**Re: Headquarters Road over Tincum Creek Replacement Project
Permit No. E0901120-026, Pennsylvania Department of Transportation**

The Delaware Riverkeeper Network and Maya van Rossum, the Delaware Riverkeeper, submit the following comment in opposition to the Joint Permit Application (“Application”) submitted by Pennsylvania Department of Transportation (“PennDOT”) Engineering District 06. PennDOT proposes to demolish the historically invaluable Headquarters Road Bridge (also known as Sheephole Bridge or Burnt Mill Bridge) along Tincum Creek located in the Ridge Valley Rural Historic District in Tincum Township, Bucks County, and construct a modern two-lane bridge in its place (hereinafter, the “Project”).

Slide 3: Stabilization Plan with notes

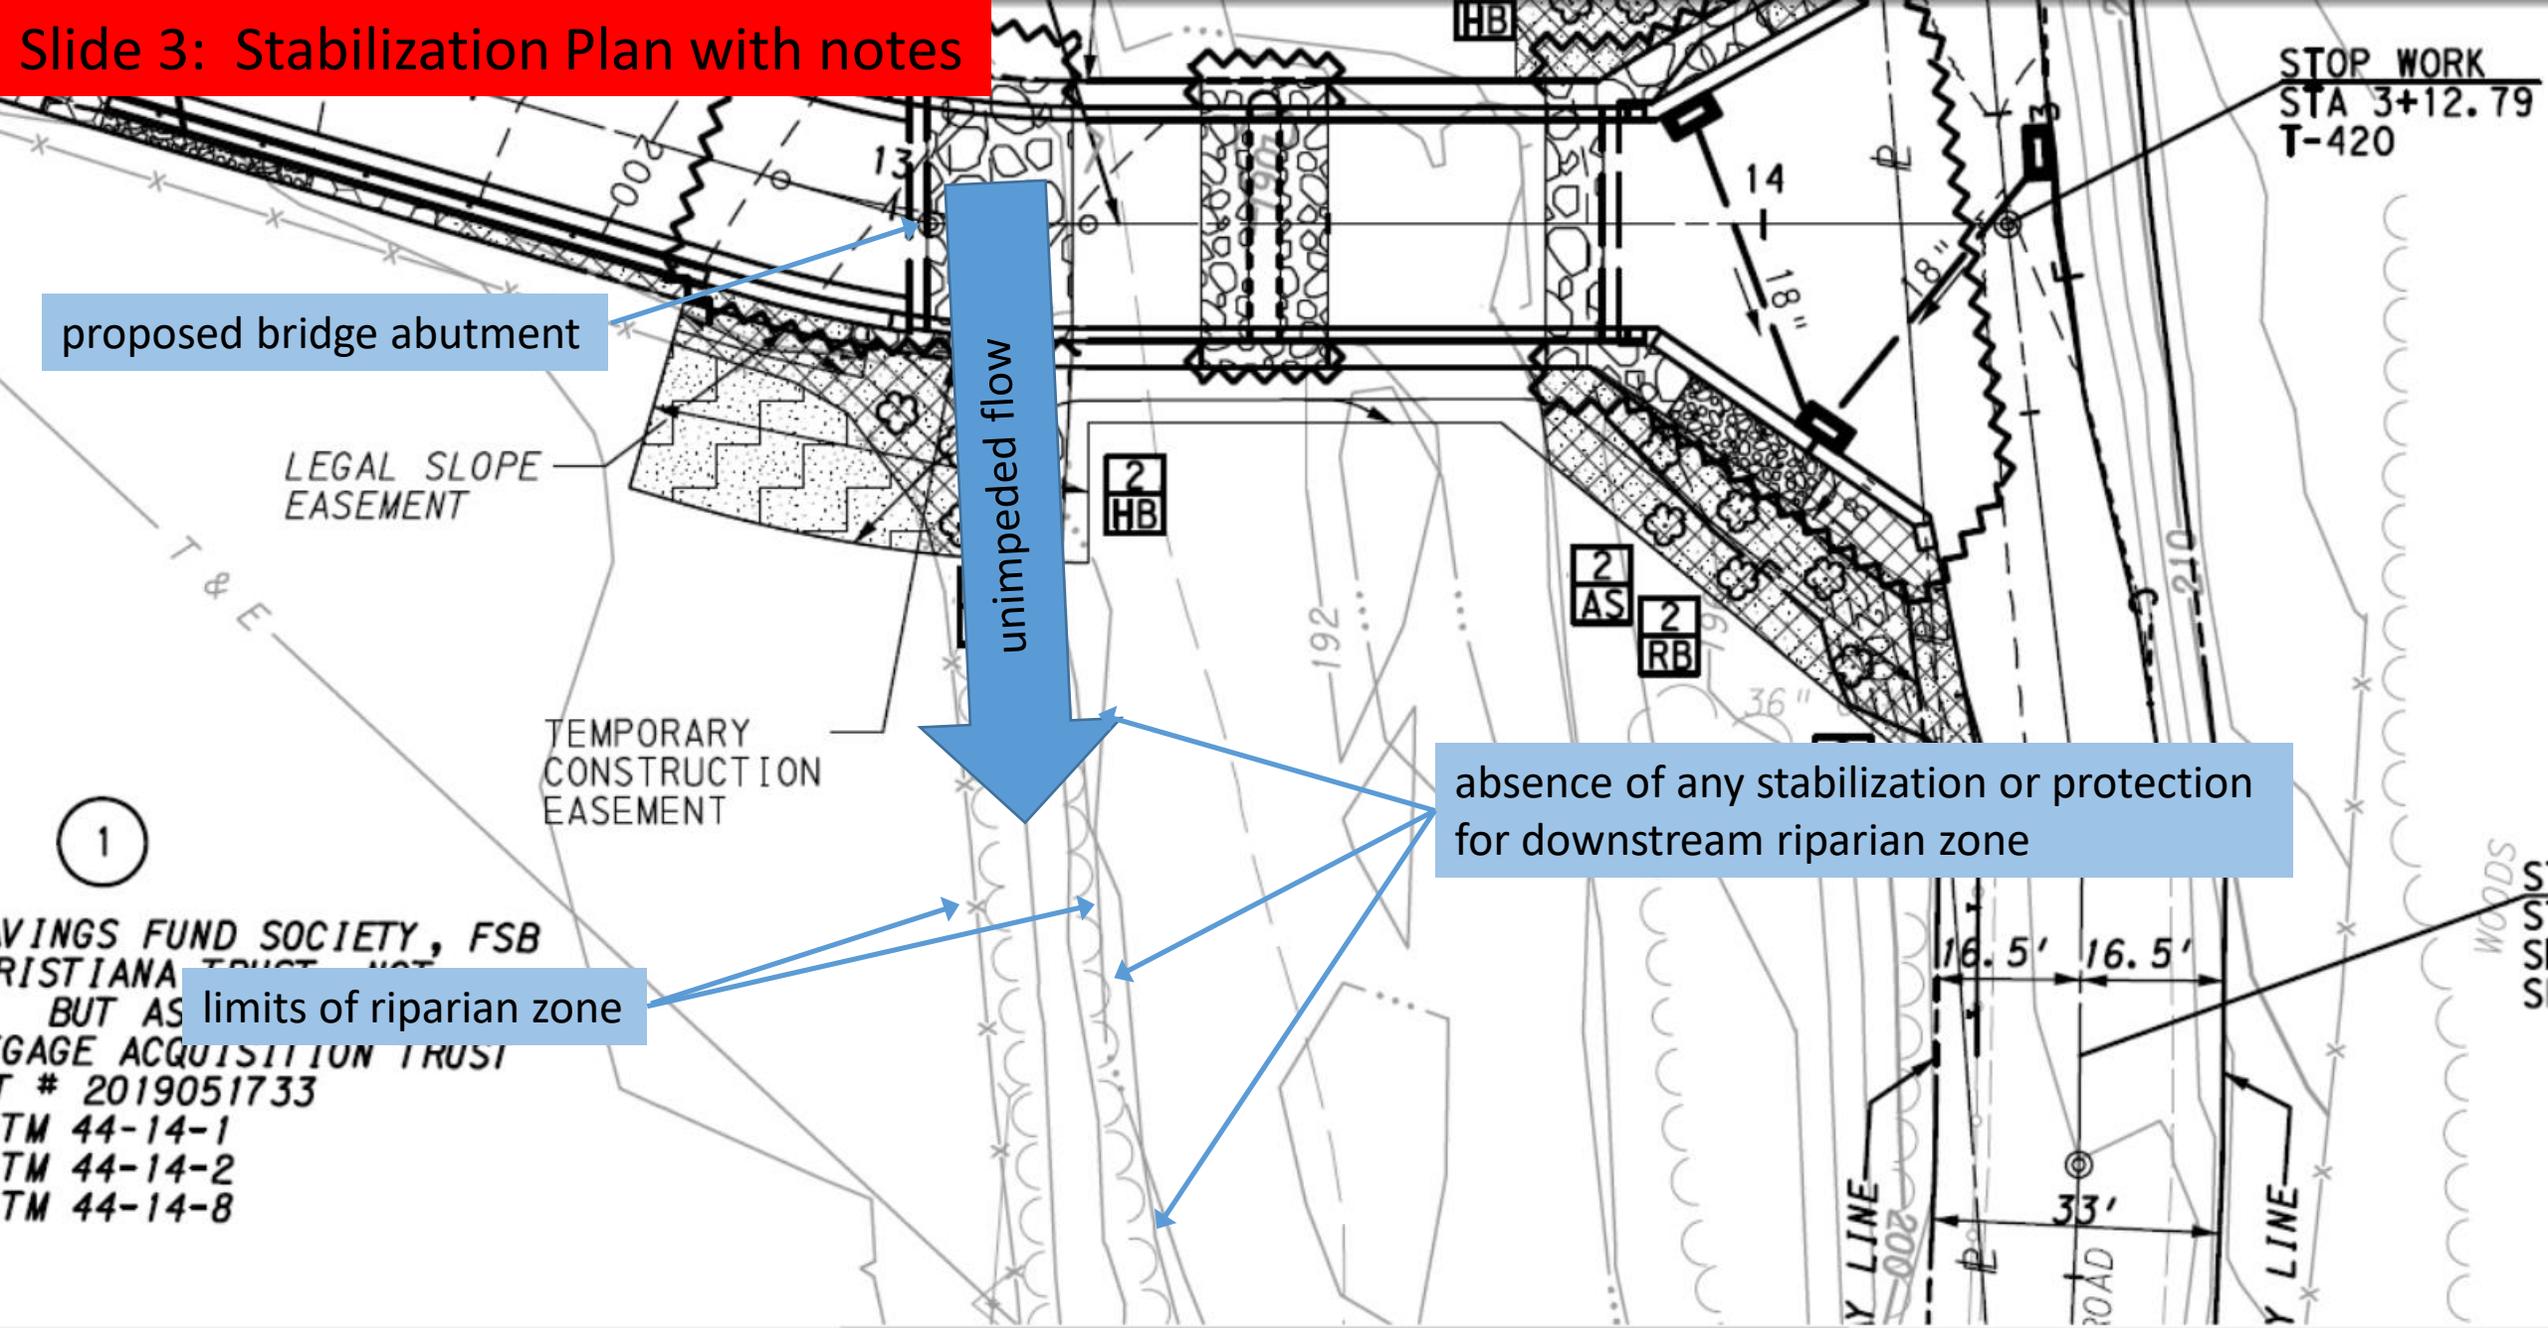
zoom in on "Stabilization Plan" (sheet 11 of 11)

New Bridge Rendering Looking Downstream (from PennDOT)

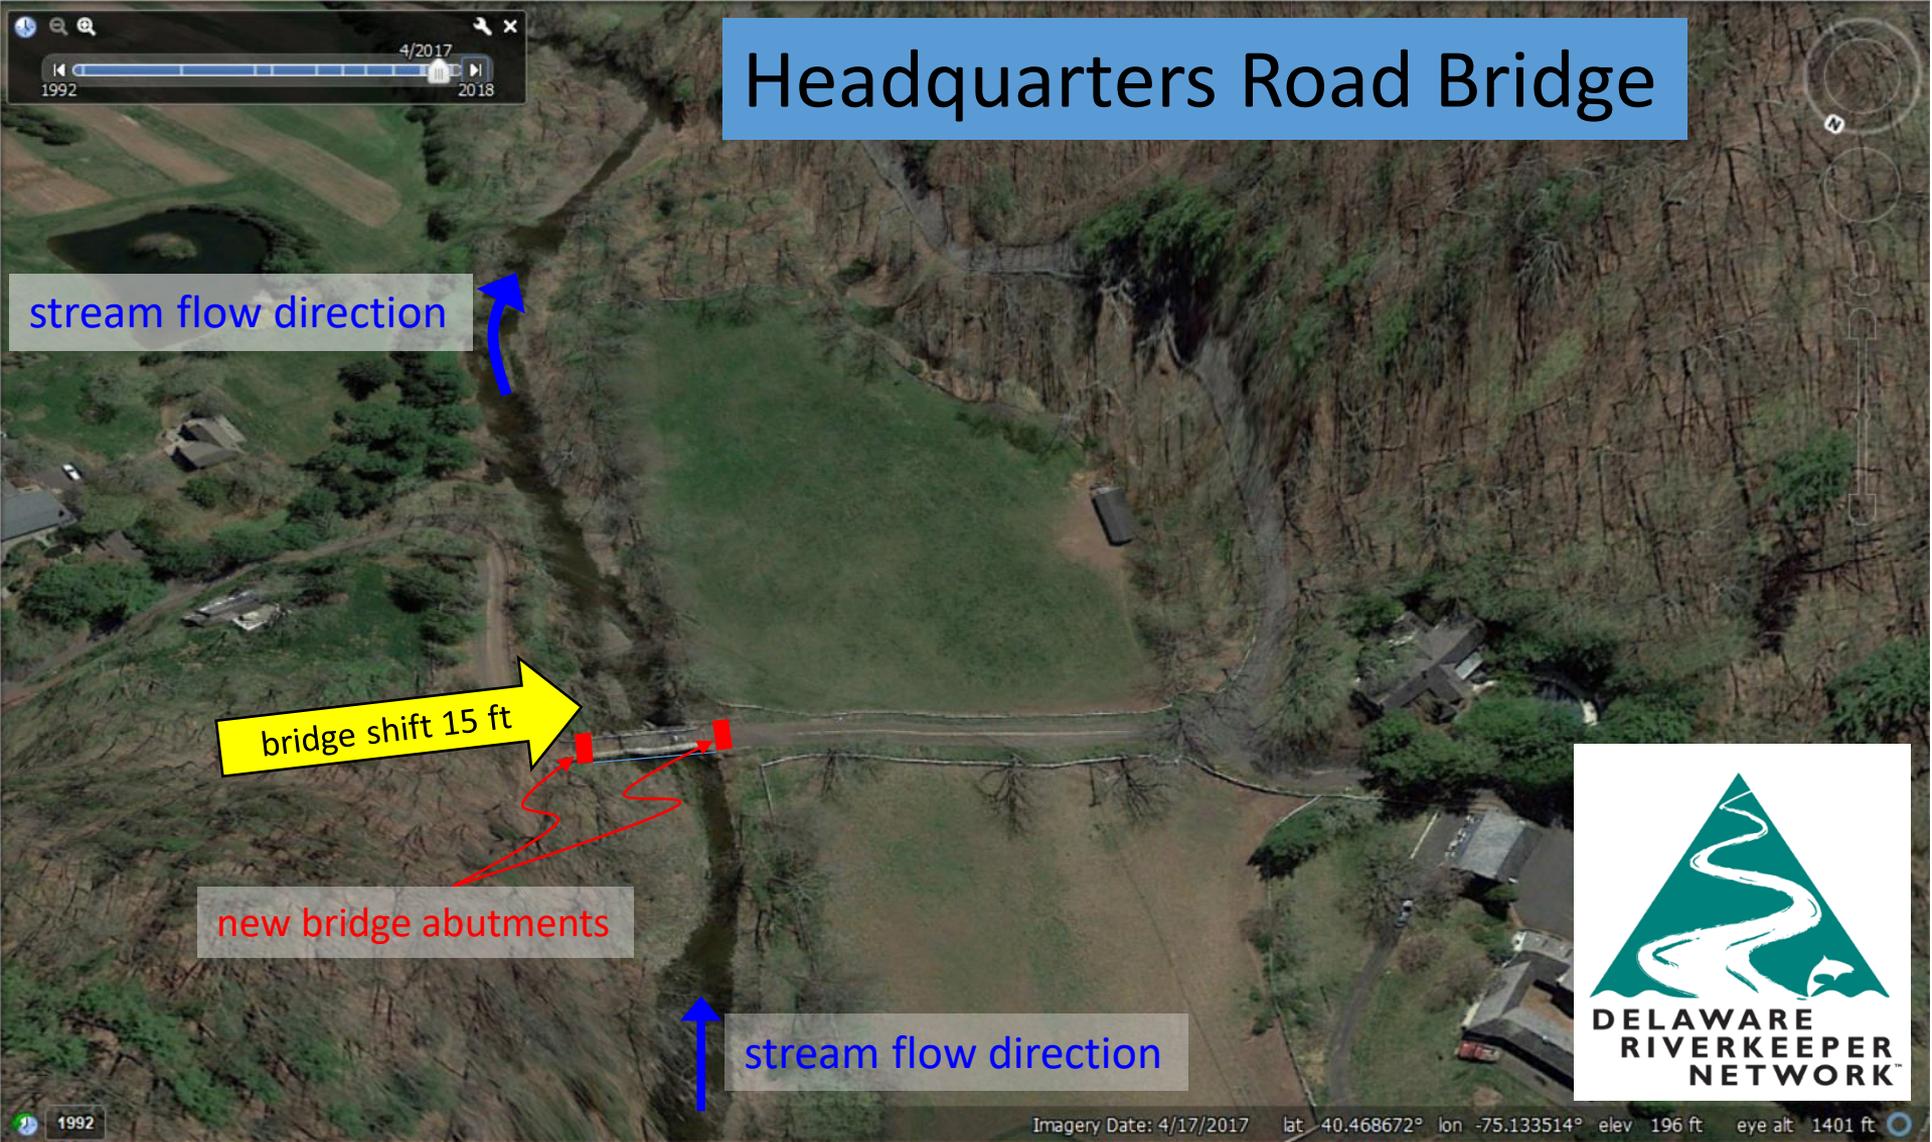
** note the exposure and impact to the downstream riparian corridor on RiverRight

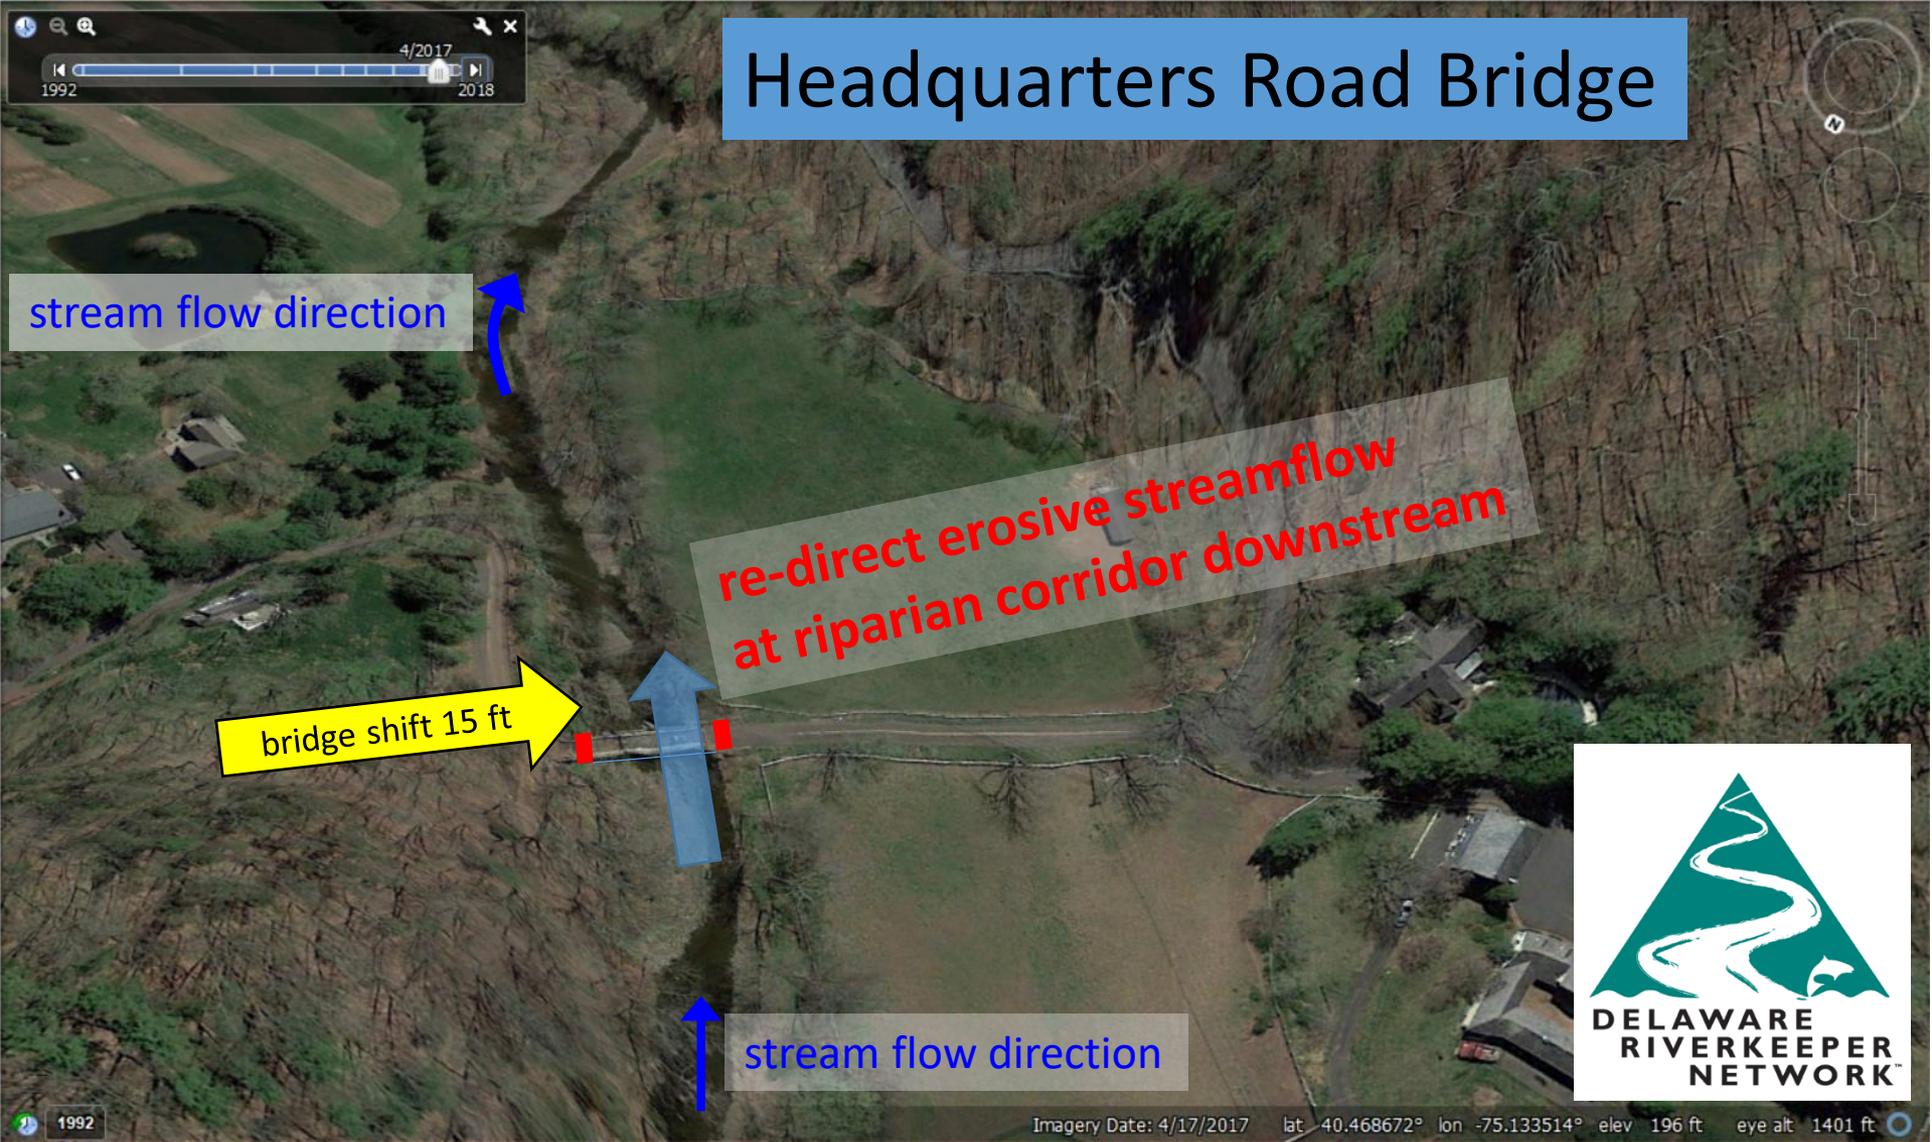
1. PennDOT proposal moves bridge abutments southwest

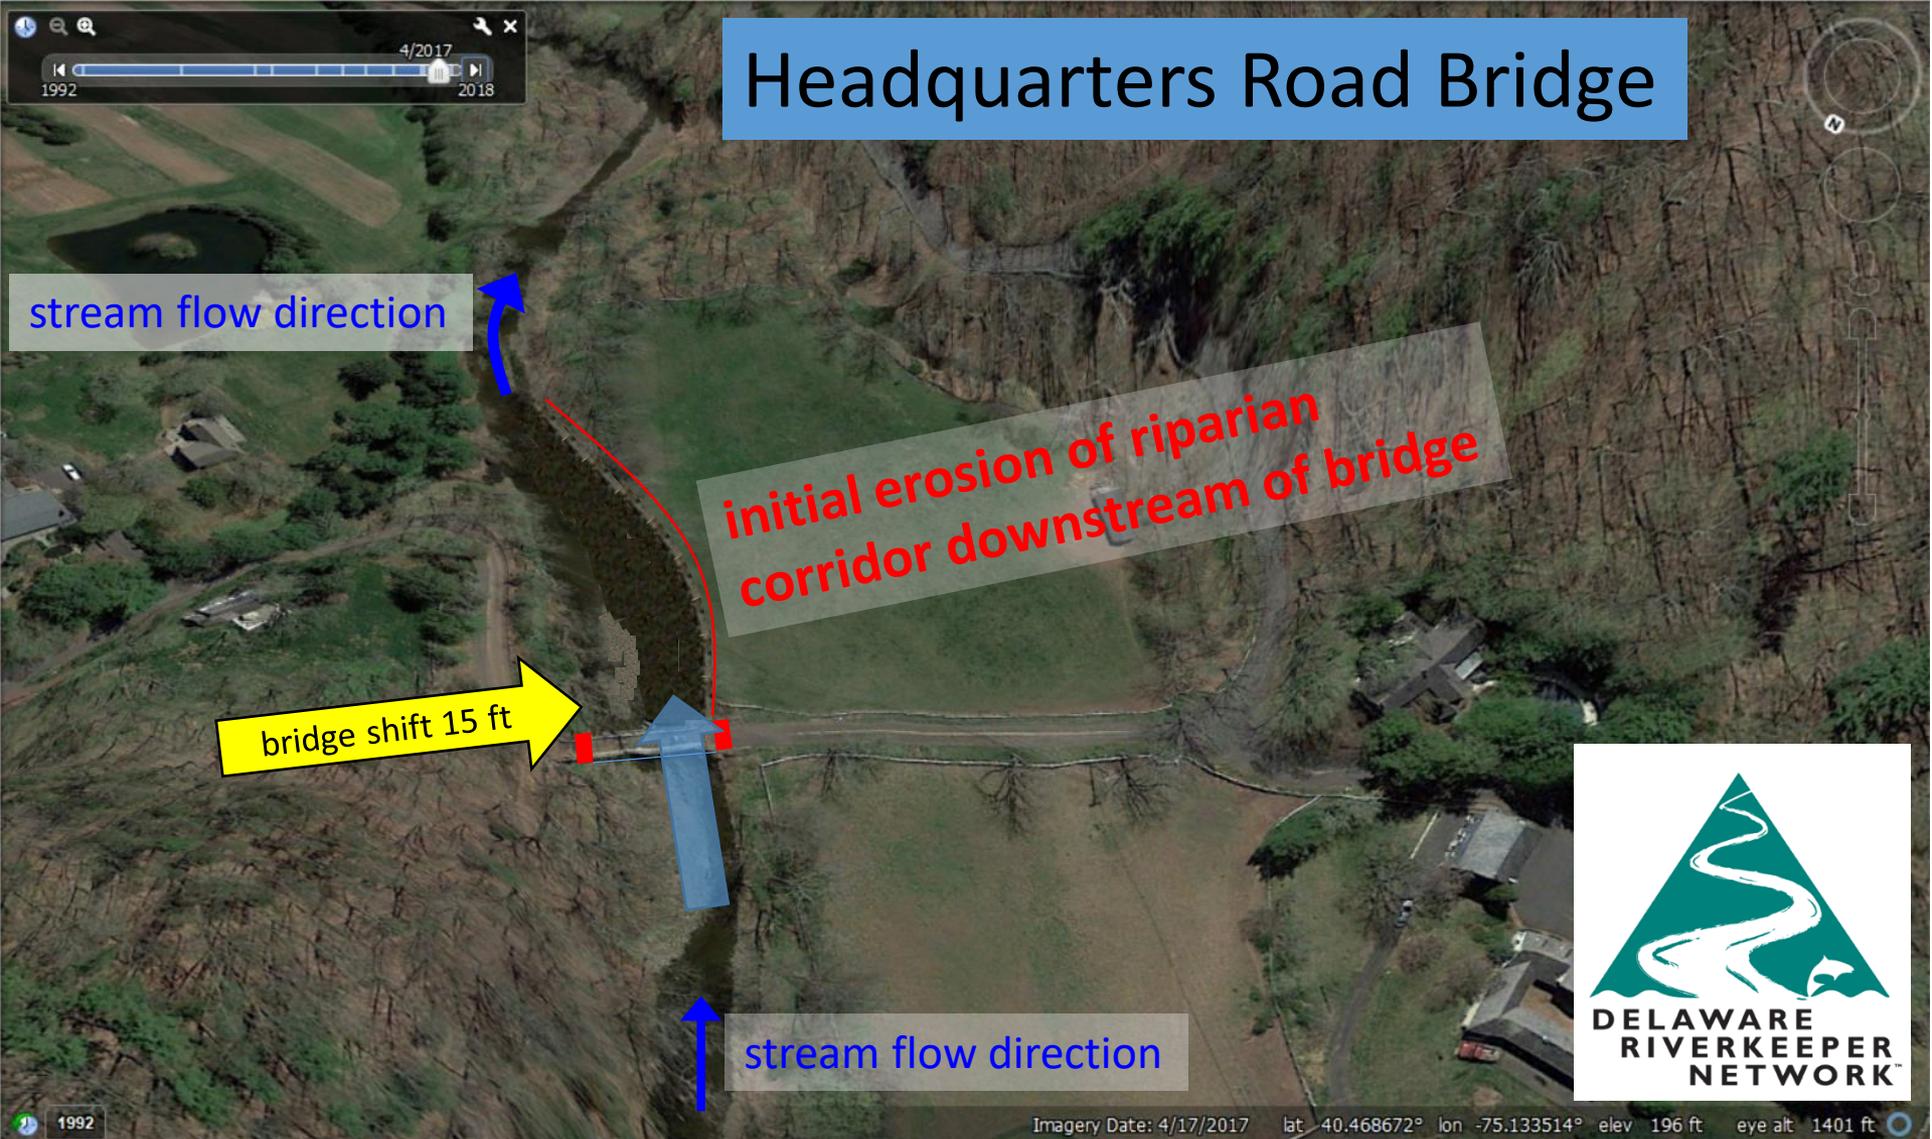
2. Bridge movement re-directs high flows directly at downstream stream banks & riparian zone
